Certificate of Appropriateness

2722 N Grant Boulevard

Replace existing main residence and garage roofs with Atlas Pristine Pinnacle shingles in Weathered Wood. Replace sheathing with 7/16 plywood. Install new gutters, flashings, hangers, sewer vent stack flashing, valley materials, and ice and water shield in gutter lines. Tuckpoint chimney, install new flue, install new chimney cap and steel flashing.

Existing chimney

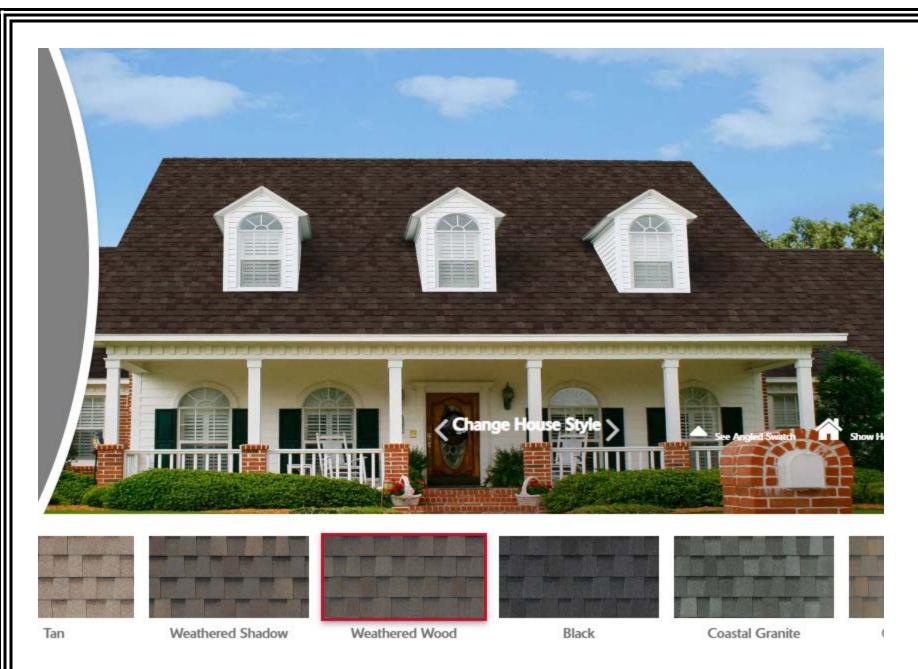
The chimney must exactly match the historic including bonding pattern, corbeling, and other details. When installing new flashing at a masonry feature, the flashing must be stepped or cut into the mortar joints. The bricks may not be cut to install flashing at an angle.

New mortar must match the original mortar in terms of color, texture, grain size, joint width, and joint finish/profile. The compressive strength of the repointing mortar shall be equal or less than the compressive strength of the original mortar and surrounding brick or stone. The replacement mortar shall contain approximately the same ingredient proportions of the original mortar. Mortar that is too hard is subject to premature failure and could damage the masonry. See the city's books *As Good As New* or *Good for Business*, Masonry Chapters, for more information. In most cases, this means a lime mortar with natural hydraulic cement rather than Portland cement. No joint of a width less than 3/8" may be cleaned of

damaged/decomposed mortar with power disc grinders. No over-cutting of the joints is permitted. Remove decomposed mortar back into the wall 2.5 times the height of the joint before repointing. When installing new flashing at a masonry feature, the flashing must be stepped or cut into the mortar joints. The bricks may not be cut to install flashing at an angle.
